Issue Date	Rev	Description	Drawn	Checked
15/09/2016	A	ISSUED FOR DEVELOPMENT APPLICATION	DVI	LT
07/02/2017	B	DEFERRED COMMENCEMENT - DA AMENDMENTS	DVI	LT
13/03/2017	C	SECTION 96 - LIGHTWELL	DVI	LT
24/05/2019	D	SECTION 96	DVI	LT
APRIL 2020	F	REVISED SECTION 96	DVI	LT

PROJECT	
GARLING HOUSE PROPOSED NEW RESIDENCE 24 LANCASTER CRESCENT, COLLAROY NSW LOT 3 DP.11899	
FOR MR & MRS GARLING

DRAWING TITLE	
PLANS SITE PLAN	
SCALE 1:200, 1:100 @ A2	DRAWN BY LT/DVI
PROJECT NO. 1612	PLOT DATE 9/04/2020
	REVISION
	DA-01 F

PROJECT	DRAWING TITLE	PLOT DATE
GARLING HOUSE PROPOSED NEW RESIDENCE 24 LANCASTER CRESCENT, COLLAROY NSW LOT 3 DP.11899	SECTIONS SECTION A + B + C	9/04/2020
FOR MR & MRS GARLING	SCALE 1:100 @ A2	DRAWN BY LT/DVI
	PROJECT NO. 1612	REVISION DA-10
		F

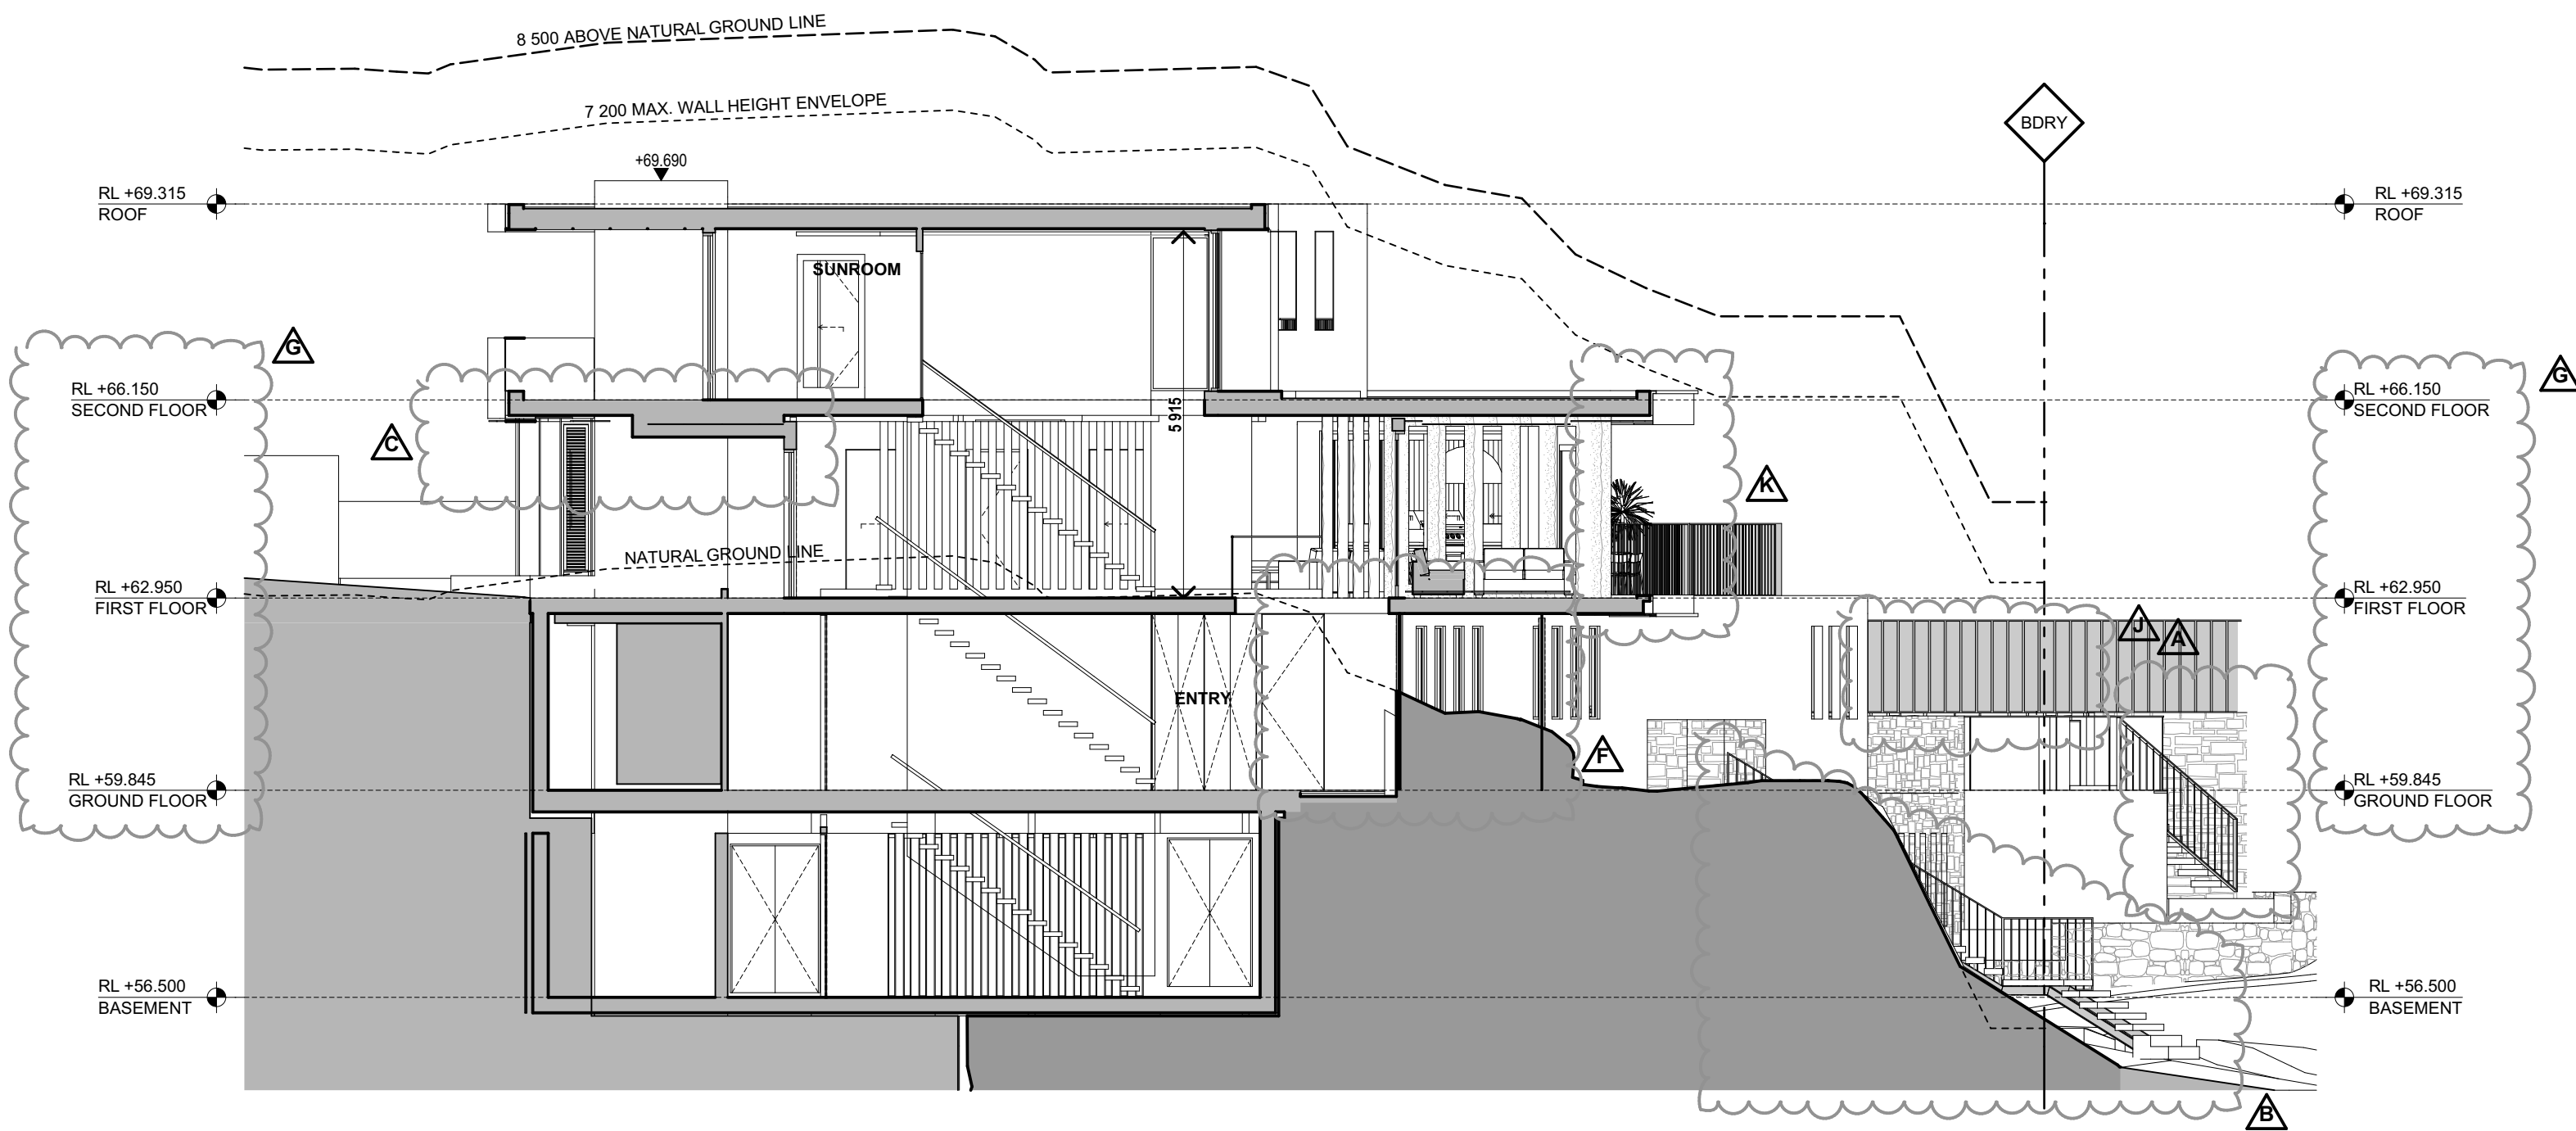
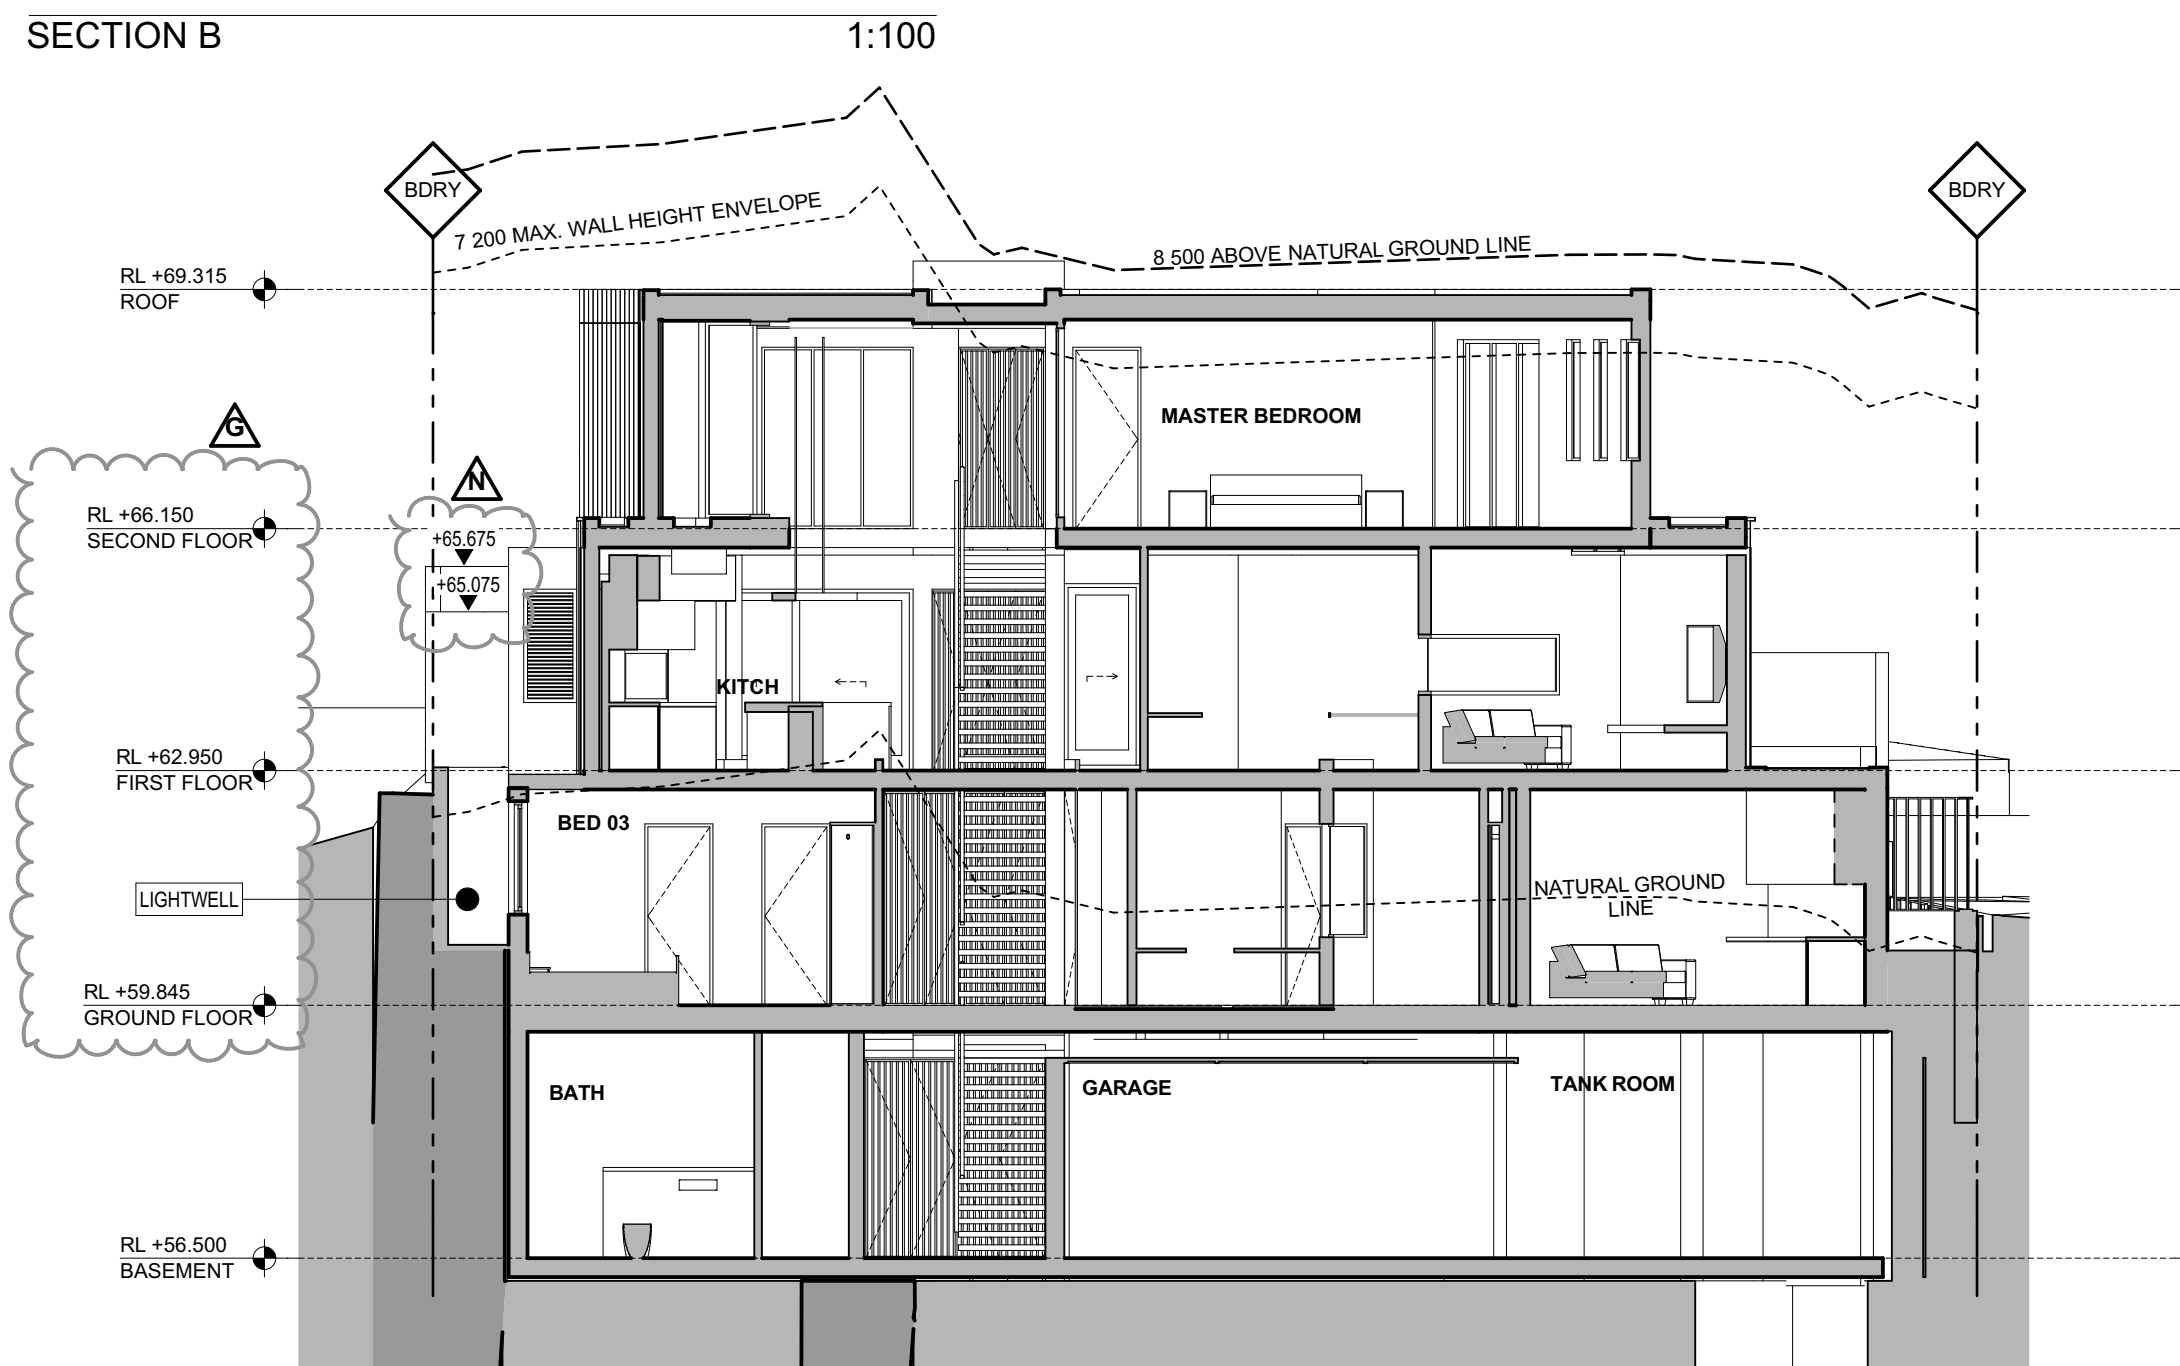
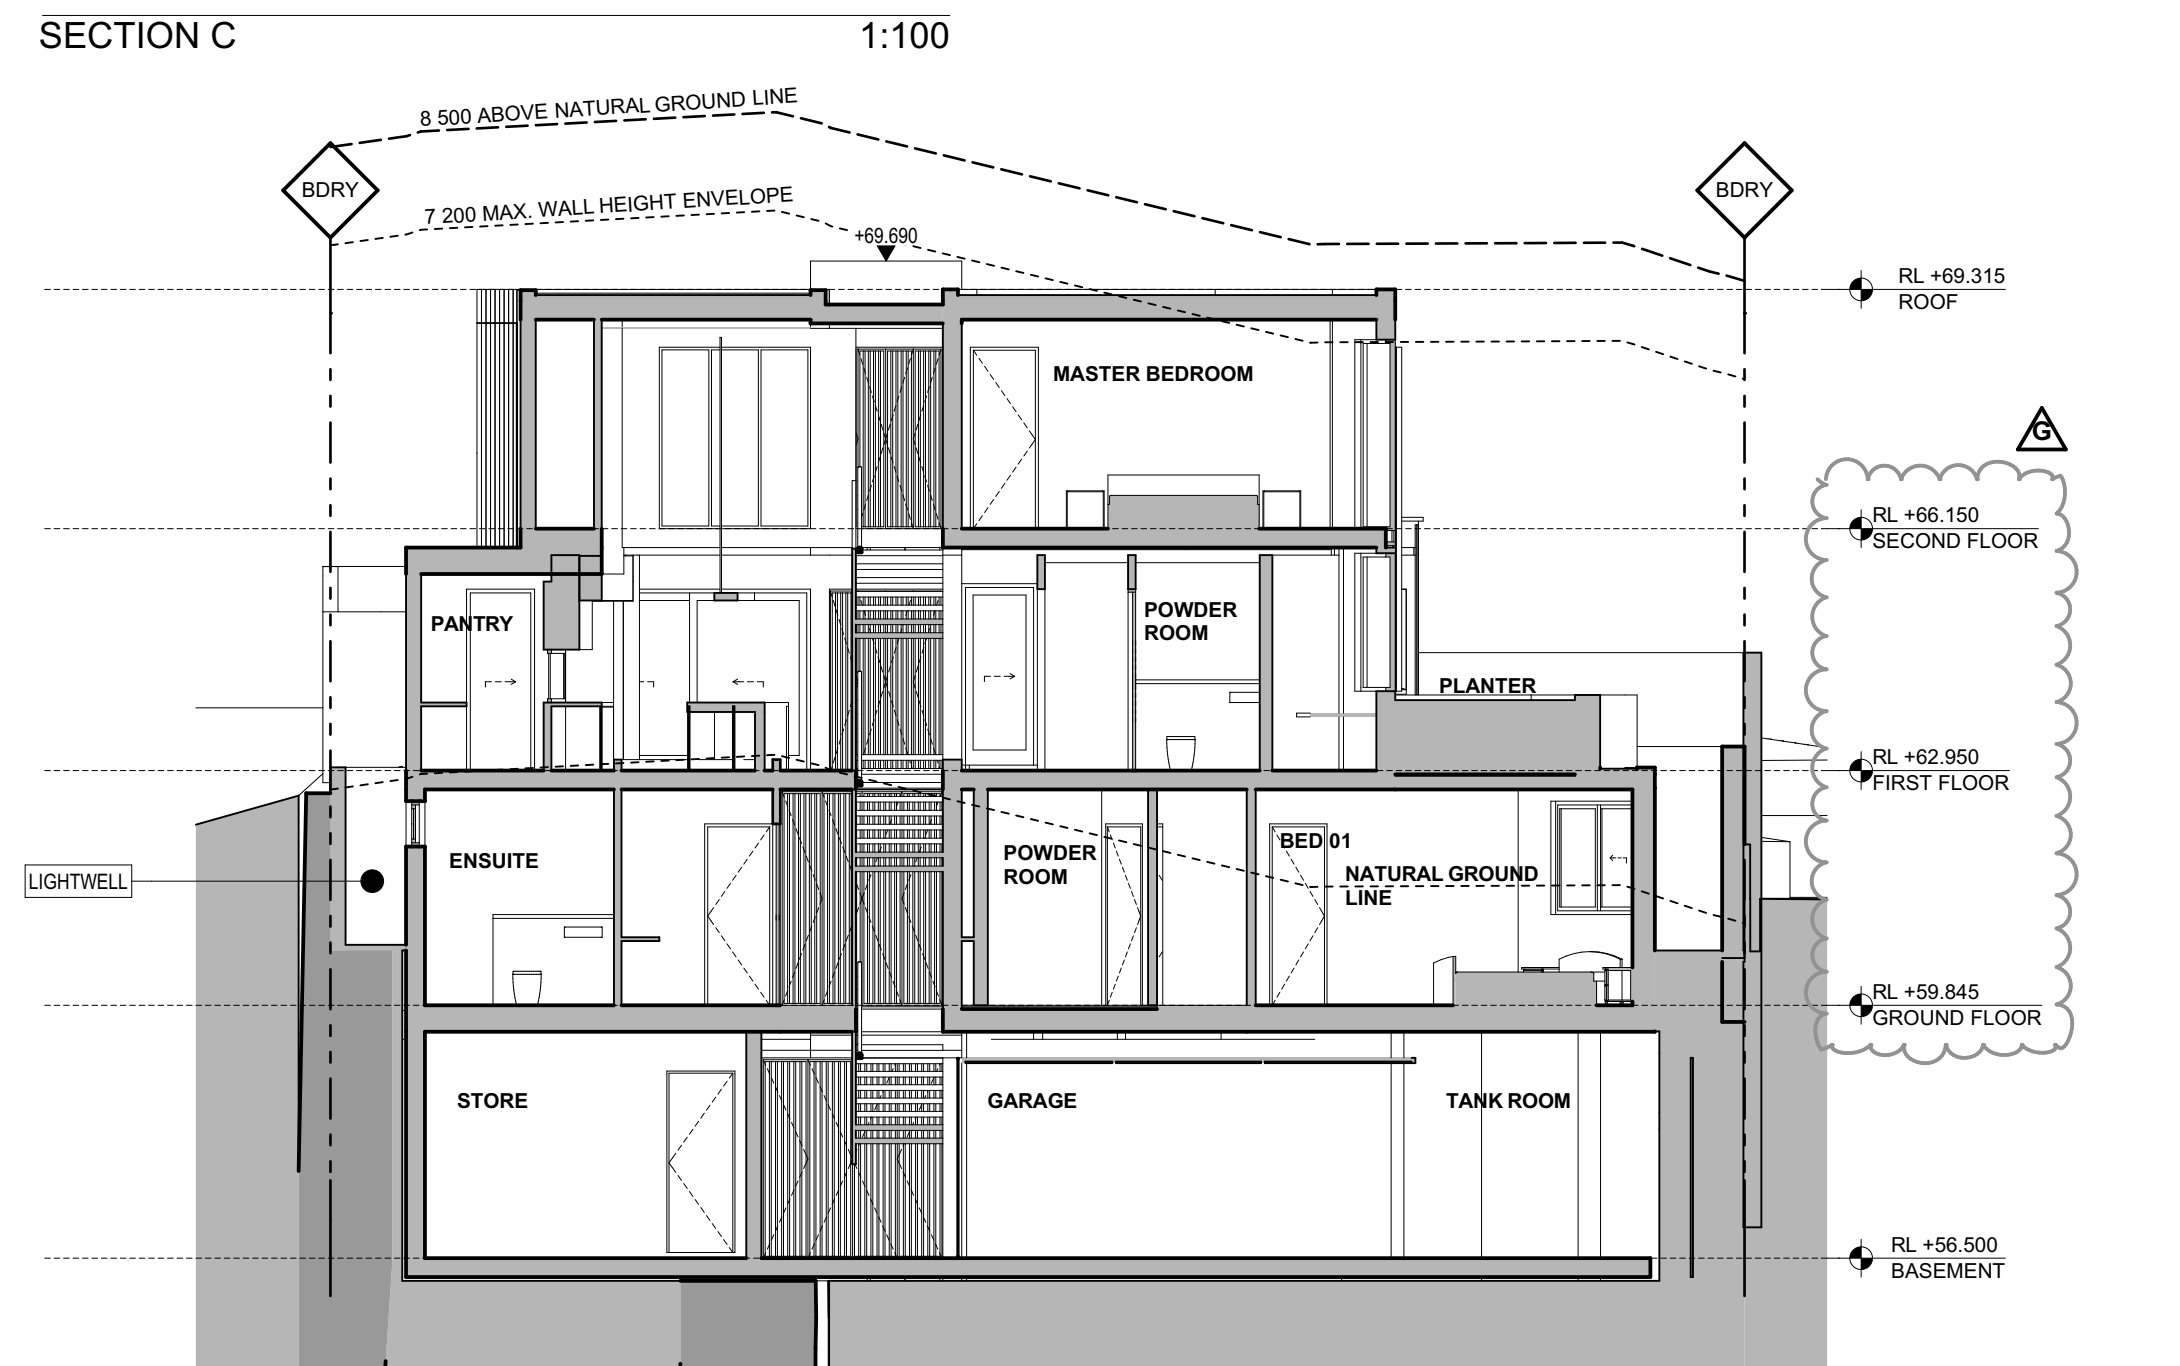
- SCHEDULE OF S96 AMENDMENTS**
SECTION A + B + C
- A** ACCESS GATE AND STAIR FROM POOL ENCLOSURE TO ALLOW ACCESS TO STREET FRONT LANDSCAPE AREA
 - B** STREET FRONT ACCESS STAIR AMENDED TO SUIT ROCK FACE AND ENTRY STURCTURE REMOVED
 - C** REAR FIRST FLOOR DECK PEGOLA REVOMED AND NEW ROOF OVER DECK
 - F** FRONT ENTRY GATE + VESTIBULE AND POND ADDED
 - G** FLOOR LEVELS AMENDED
NOTE NO IMPACT ON HEIGHT
ROOF LEVEL NOT CHANGED
 - BOUNDARY POOL PRIVACY SCREEN ADDED TO TOP OF WALL
 - K** ENTRY PERGOLA STRUCTURE REMOVED + FRAMED VIEWING WINDOW AND WINDOW SLOTS ADDED/AMENDED
 - M** BOUNDARY FENCE LEVELS ADDED
